7C Defense Against Common-Mode Failure in Safety-Related, Software-Based I&C Systems

The information in this appendix of the reference ABWR DCD, including all subsections and figures, is incorporated by reference with the following departures.

Figure 7C-1 Implementation of Additional Diversity in SSLC to Mitigate Effects of Common-Mode Failures

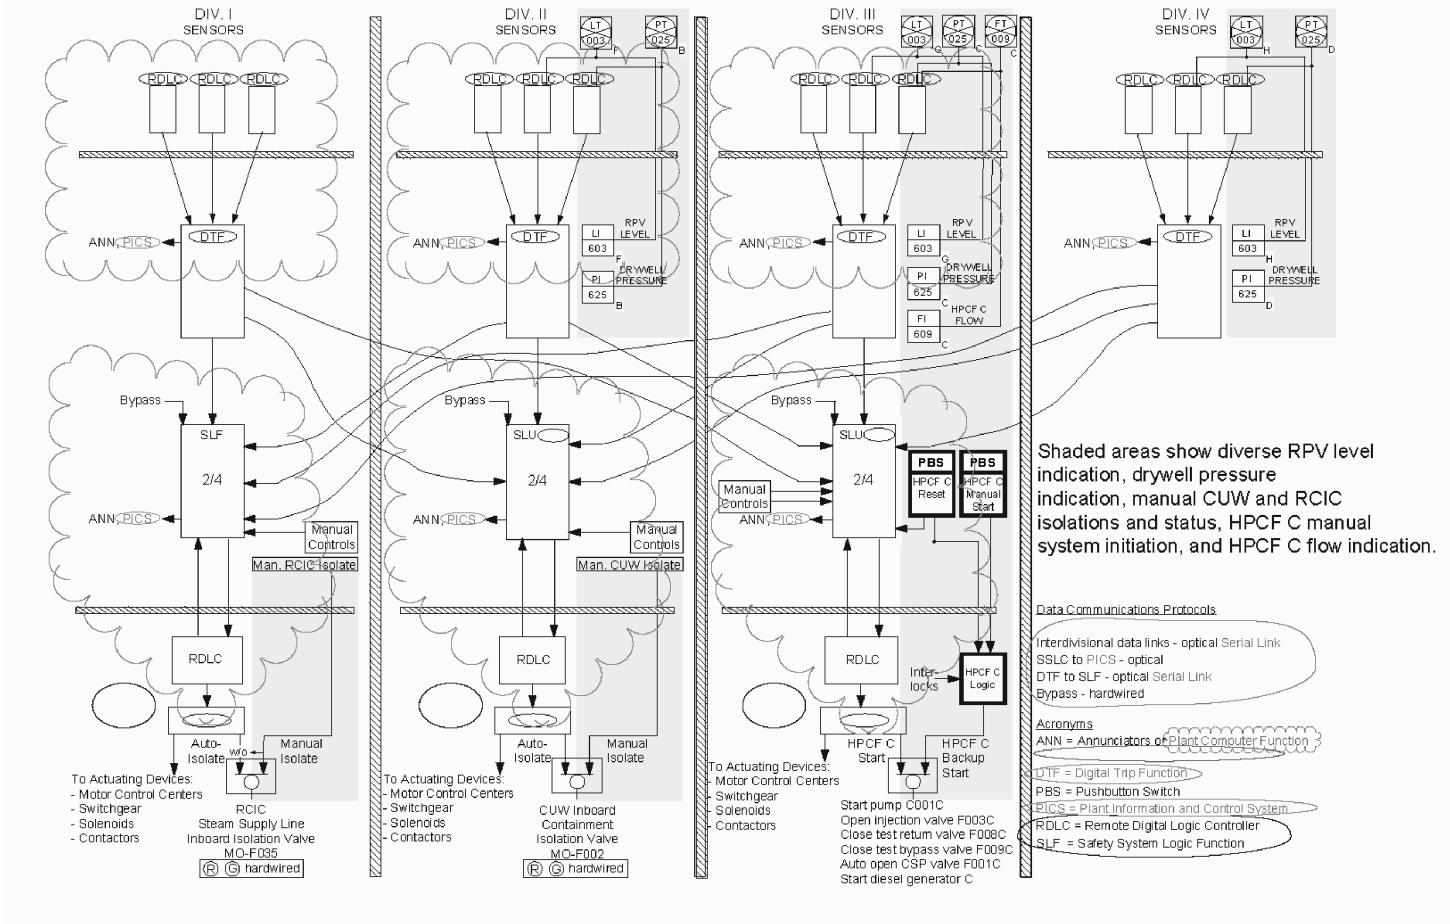
STD DEP T1 3.4-1 (Figure 7C-1)

To maintain protection system defense-in-depth in the presence of a postulated worst-case event (i.e., undetected, 4-division common mode failure of all communications or logic processing functions in conjunction with a large break LOCA), diversity is provided in the form of hardwired backup of reactor trip, diverse display of important process parameters, defense-in-depth arrangement of equipment, and other equipment diversity as outlined below (many of these features were included in the original protection system design; refer to Figure 7C-1 for details of how those additional diverse features, added as a result of the CMF analyses discussed in the previous section, have been implemented). Note that diverse equipment can be in the form of digital or non-digital devices as long as these devices are not subject to the same common mode failure as the primary protection system components:

- (2) Defense-in-depth configuration:
 - (a) Fail-safe RPS and fail-as-is ESF in separate processing channels
 - (b) Control systems ~~supporting diverse injection~~ are independent of RPS and ESF in separate ~~triplicated processing network~~ communication functions using diverse hardware and software from the ~~Essential-Multiplexing System~~ Essential Communication Function (ECF) network
- (3) Equipment diversity
 - (d) HPCF manual start in loop C (Division III) is implemented in equipment that is diverse from the automatic start function. All interconnections are hardwired and control and interlock logic is provided in the form of either

discrete logic gates or programmable logic that is diverse from the automatic start logic. The signal path of the manual logic is independent from that of the automatic logic up to the actuated device drivers (e.g., motor control centers or switchgear). The manual start function is not implemented in the automatic logic; ~~however, the logic reset switch is common to both the automatic and manual logic.~~ In addition to the manual start function, which performs all necessary control actions as a substitute for automatic start, other supporting hardwired functions are provided in loop C as follows:
